Access Compliance Report Public Rights-of-Way (Pedestrian Signals)

Main Street: GILBERT_ST Cross Street: KATELLA_AVE Location: SW

ADA ID: SGRK210916134150 Signal Type: One Push Button-Non APS Overall Compliance: No Severity Scores: BTN 1: 25 BTN 2: N/A No BTN: N/A

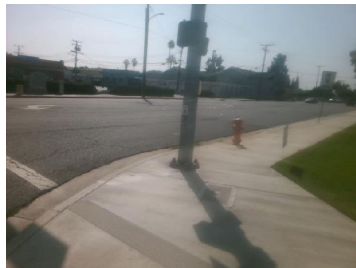
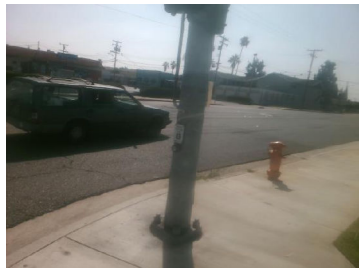
Yes B 1 Closed Fist Operation?	Yes	N/A	B 2 Closed Fist Operation?	N/A	
Yes B 1 Diameter (in)	2	N/A	B 2 Diameter (in)	N/A	
N/A B 1 Crossing Direction	E	N/A	B 2 Crossing Direction	N/A	
No B 1 DistanceTo XWalk (in)	72	N/A	B 2 DistanceTo XWalk (in)	N/A	
Yes B 1 DistanceTo Curb (in)	40	N/A	B 2 DistanceTo Curb (in)	N/A	
Parcel Identification Number	132-071-40				
Google Street View Link					
http://www.google.com/maps/@?api=1&map_action=pano&viewpoint=33.8028975,-117.9676971

Possible Solutions: Replace Signal Push Button With APS Button. Remove & Relocate Sign.
